# HOSHIZAKI AMERICA, INC.

## SERVICE BULLETIN

**SB99-0011**

### **Subject: DCM Shutter Mechanism**

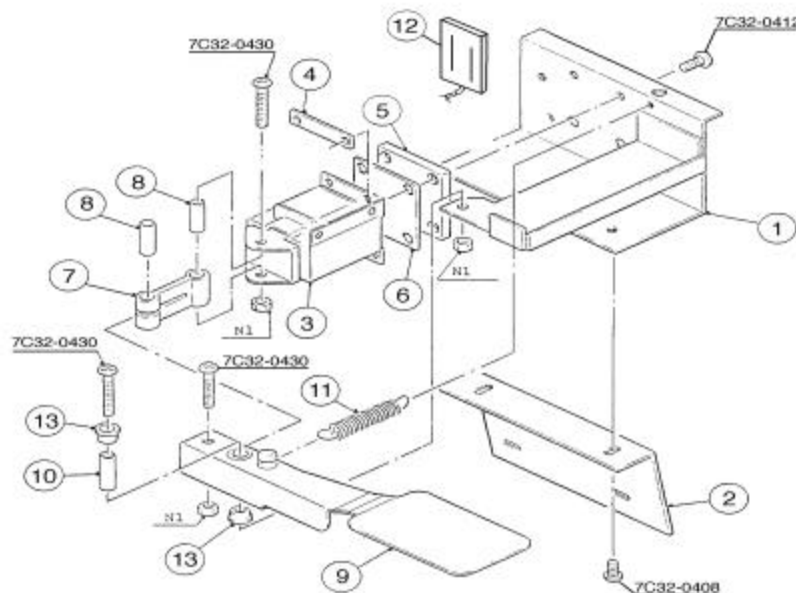
It has been reported from the field that the shutter lever # 9 has been coming loose from the solenoid assembly on new DCM-500 B models. An investigation has revealed that the wrong nuts were used in the assembly process. Evidently, we got our nuts mixed up. The N1 nuts should be the nylon self-locking type. Standard nuts were used on some assemblies and in some cases, lock tight sealant was used. If standard nuts were used without sealant, they will back off of the screw as the shutter operates. This problem could show up on any DCM-500 or DCM-750 model.

The part number for the correct lock nut is 7N22-0400. There are 3 on each shutter assembly. We ask that you order some of these nuts and if you go out on a DCM-500/750 call, check the shutter assembly. Replace the standard nuts with these to eliminate the possibility of a loose lever. If the call is warranty, note that the nuts were changed on the warranty form. See the

**drawing below for the three N1 nut locations.**
